INFORMATION PACKAGE FROM THE RESIDENTS OF 1279 NICOLA STREET

Primary Objection

Illustration 1. Impact of proposed design on courtyard

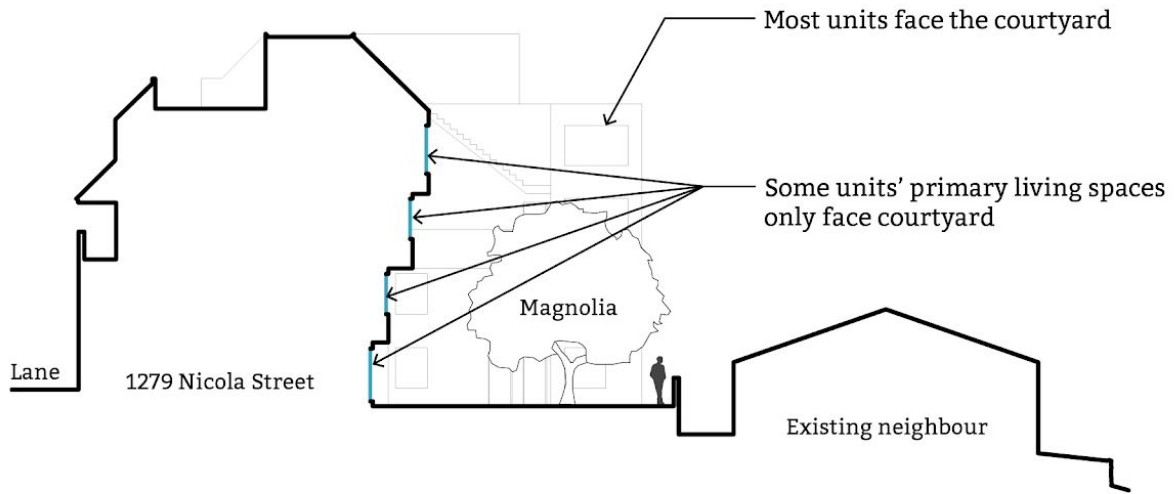
1. Our building is oriented around a courtyard that faces the shared property line. **For most of the units in our building, the *only* significant access to light, air, and a sense of space is through the courtyard.** The proposed development will lock the courtyard in a deep, narrow light well. We recognize that this is an atypical condition, but the result will be severe for our residents. An atypical solution is needed from the applicant and City.

Illustration 2. View from typical courtyard-facing living room (Unit 107)

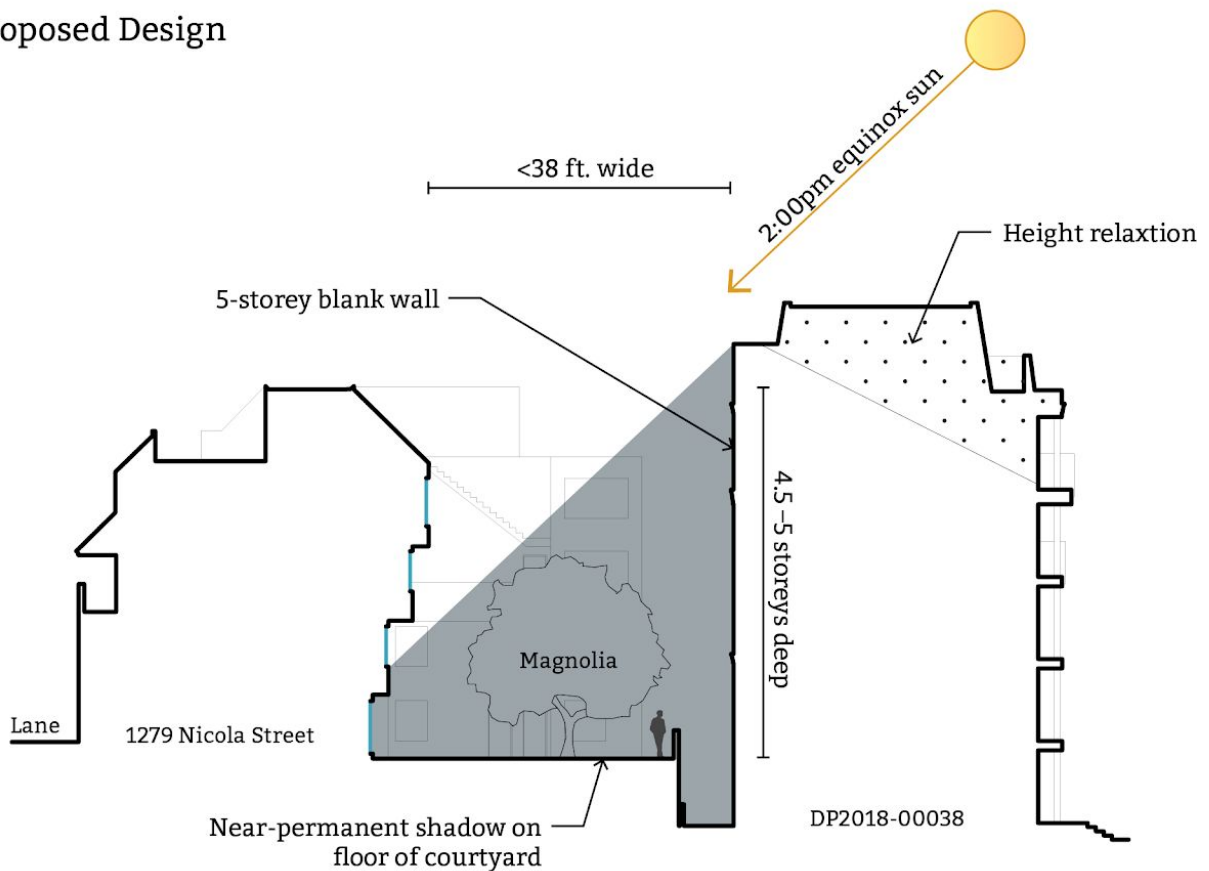
Note that the window in this photo, in addition to sliding doors directly below, is the *only* window from a primary living space that this unit has. This unit's only other window is a small window from a back bedroom looking directly into the laneway.
